Subject: REBUTTAL TO DP# 458797, DATED 10/08/2020

Product Name: Thermacell Radius Zone Mosquito Repellent VI

EPA Reg. No or File Symbol: 71910-11

I. Action Requested: The registrant requested review of a rebuttal argument (no MRID, email submission) in response to the previous review (DP 458797), dated 10/08/2020.

Radius liquid release was measured from a 12-hour release test with a 5.5% metofluthrin Radius liquid (ECS-G-233) filled in 12-hour Radius refills using Radius units EID-19-018-1A/B/C/D/E/F. Lab book reference: ECS-48-035.

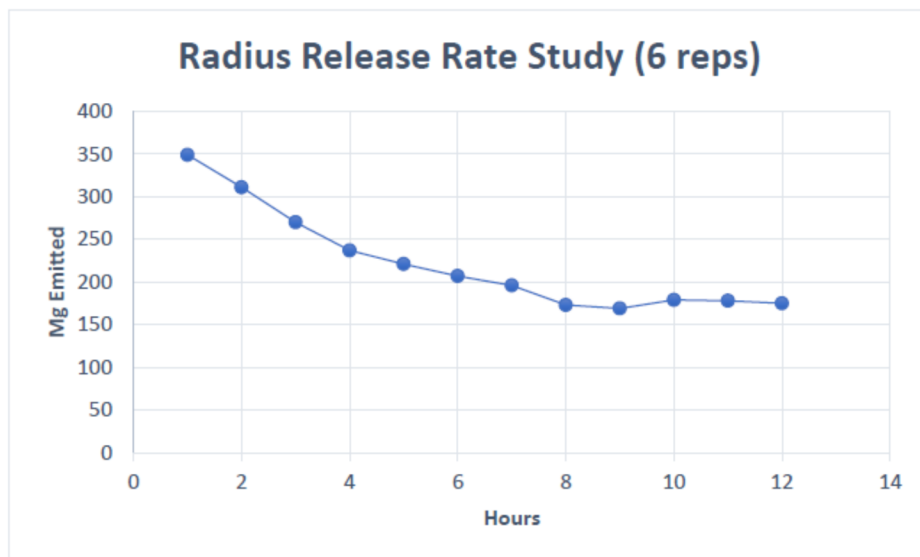
Rebuttal Point #1. *We have adopted a practice of conducting a two-hour pre-burn before initiating efficacy studies in order to ensure that the efficacy data will be representative of the majority of the life of the product refill. The*

early-use emissions for these refills is typically a little higher than that of the remainder of the refill life. The efficacy in the early hours should be at least as good as later hours, but are not consistent with later release rates. The chart below provides an illustration of this.

Agency Response to Rebuttal Point #1. Thank you for providing this information. The chart submitted is only showing release rates of the device over time. The chart shows that the initial release is higher than later times, and it does not stabilize until 8 hours after burning. There is no efficacy data submitted to see how efficacy changes over time. While efficacy data may have illustrated the rationale for the 2-hour pre-burn better, the Agency would not have reviewed this new data, as new data are not typically reviewed with a rebuttal submission. The outstanding issue is that the product was tested using a 2- hour pre-burn somewhere else, and the efficacy testing was performed after that period. Products should be tested in the same manner that they are going to be used.
